Access Compliance Report

Public Rights-of-Way

Intersection ID: 11671	Main Street: PARKWOOD_AV	Cross Street: N_CALDWELL_ST	Location: S
ADA ID: AE17FF45D67F	Ramp Type: Perp	Initial Pass/Fail: Fail	Overall Compliance: No
		Severity Score: 12.5

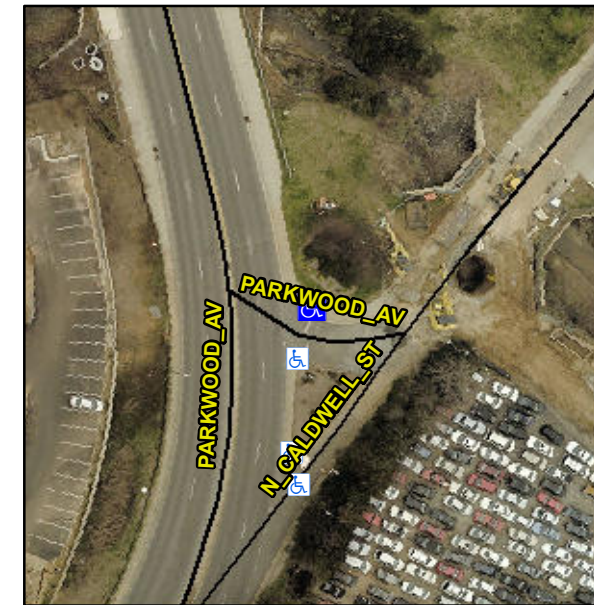
Not Found, R304.2.2

Compliance	Description	Data	Compliance	Description	Data
N/A	Ramp Length (in)	60.0	No	Ramp Slope (%)	9.0
Yes	Ramp Width (in)	51.0	Yes	Ramp XSlope (%)	1.3
N/A	Flare Type LT	N/A	N/A	Flare Type RT	N/A
N/A	Flare Slope LT (%)	N/A	N/A	Flare Slope RT (%)	N/A
N/A	Flare Traversable LT?	N/A	N/A	Flare Traversable RT?	N/A
N/A	Landing Length (in)	N/A	N/A	DWS Provided?	N/A
N/A	Landing Width (in)	N/A	N/A	DWS Contrast?	N/A
N/A	Landing Slope (%)	N/A	N/A	DWS Length (in)	N/A
N/A	Landing X Slope (%)	N/A	N/A	DWS Full Width?	N/A
N/A	Landing Curb? (Y/N)	N/A	N/A	DWS Offset (in)	N/A
N/A	Shared Landing?	N/A			
N/A	Gutter Ponding?	N/A	N/A	Gutter Slope (%)	N/A
N/A	Gutter Lip Ht (in)	N/A	N/A	Gutter X Slope (%)	N/A
N/A	Painted X Walk1?	No	N/A	Painted X Walk2?	N/A
	X Walk 1 Direction	To S		X Walk 2 Direction	N/A
N/A	X Walk 1 Width (in)	N/A	N/A	X Walk 2 Width (in)	N/A
	X Walk 1 Slope (%)	3.8		X Walk 2 Slope (%)	N/A
	X Walk 1 X Slope (%)	0.3		X Walk 2 X Slope (%)	N/A

Remove & Replace Entire Ramp.
